**INFORMATION BULLETIN**No. M 137 A/2  
M 337/69

- COVERS:** LUN 2221.13 magneto, drawing number 252-9276.57, inspection and servicing of magnetoes attached to M 137 A and M 337 engines.
- REASON:** The retaining member drawing No. 402-5012.55 in the bearing cover drawing No. 402-8802.40 may become loose in some magnetoes and even drop out when the cover is withdrawn. Jamming of the retaining member inside the distributor cap can cause damage to the distributor arm and loss of its function.

FIG. 1

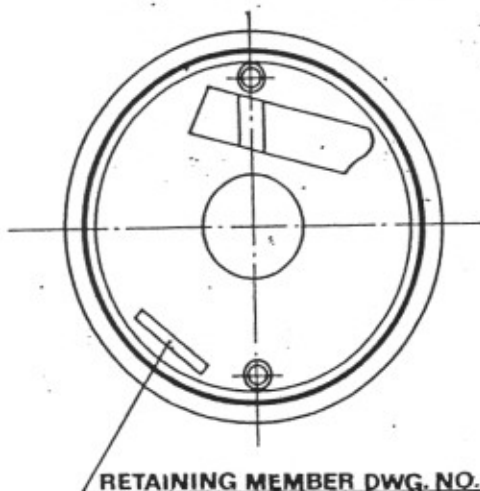
- 2) Remove the two screws fixing the distributor cap to the transformer, drawing No. 402-8800.63 and put the cap in a clean box.
  - 3) Using flat pliers with a long nose (ČSN 23 0363) hold the retaining member drawing No. 402-5012.55 across its narrow side (see Fig.1) and test it for possible wobble. Then hold the retaining member across its longer side and repeat the check. Should the retaining member be found to wobble during any of above checks then the magneto must be considered to be unsatisfactory and it should be returned to the manufacturer for repair. Such magnetoes whose retaining member, drawing No. 402-5012.55 does not wobble are considered satisfactory and previously disassembled subassemblies can be reattached.

- a) Replace the distributor cap with the transformer drawing No. 402-8800.63, over the magneto housing. Take care to set it properly into its retaining element and then tighten both screws.

- b) Reattach the aluminium screening housing, drawing No. 402-8465.10, to the distributor cap with the transformer. Be careful to fit the screening cover properly to its retaining element on the cap and then tighten both screws.

- c) Check reattached elements for correct fitting.
